SUBJECT: CERTIFIED MINUTES OF THE ACRS RELIABILITY AND PRA
SUBCOMMITTEE MEETING ON NUREG-1855, REV.1,
"GUIDANCE ON THE TREATMENT OF UNCERTAINTIES
ASSOCIATED WITH PRAS IN RISK-INFORMED
DECISIONMAKING", ON OCTOBER 19, 2012

**ADVISORY COMMITTEE ON REACTOR SAFEGUARDS
MINUTES OF THE ACRS RELIABILITY AND PRA SUBCOMMITTEE MEETING
OCTOBER 19, 2012**

The purpose of the meeting is to hear staff's discussion of the treatment of uncertainties associated with PRAs in risk-informed decisionmaking, NUREG-1855, Revision 1, and EPRI staff's presentation on EPRI Draft Report 1026511, "Practical Guidance on the Use of PRA in Risk-informed Applications with Focus on the Treatment of Uncertainties". The meeting transcripts are attached and contain an accurate description of each matter discussed during the meeting. The presentation slides and handouts used during the meeting are attached to these transcripts.

New EPRI Guidance

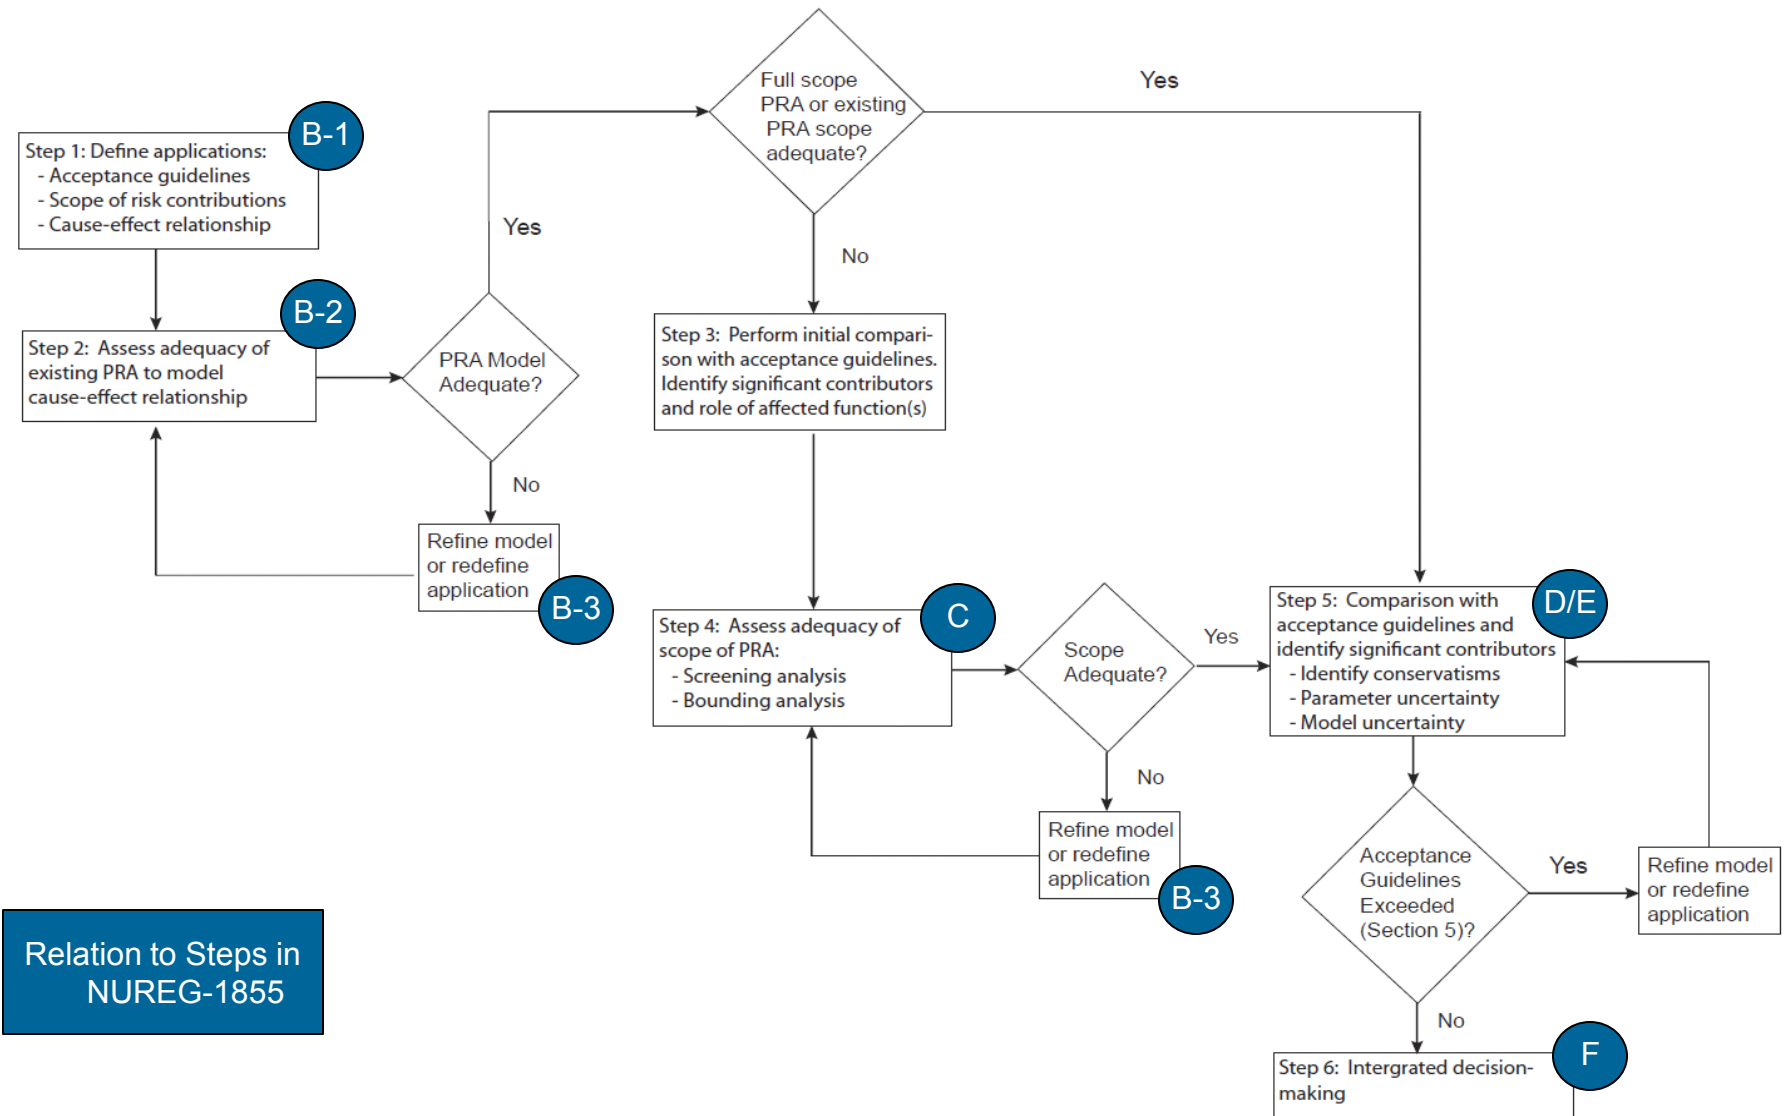
23 Okay. So now if we look at the figure, you'll
24 notice that this is different from the figure that appeared
25 in the draft document in which you had. And the difference

1 is in the first little diamond on the left-hand side
2 that says PRA model adequate, instead of going to step
3 three, now it clicks up and asks the scope question.
4 So this is a bypass of the screening and bounding part
5 of the process if you know that the PRA model you have
6 going in is of sufficient scope to deal with the specific
7 application. And this could happen if it's a full-scope
8 PRA or, say if you're only dealing with fires, that it's
9 a fire PRA.

10 So those are the only, that's the only
11 difference in the figure, except also that these nice
12 little bubbles on here which indicate which steps of
13 the 1855 process are addressed by these particular steps.
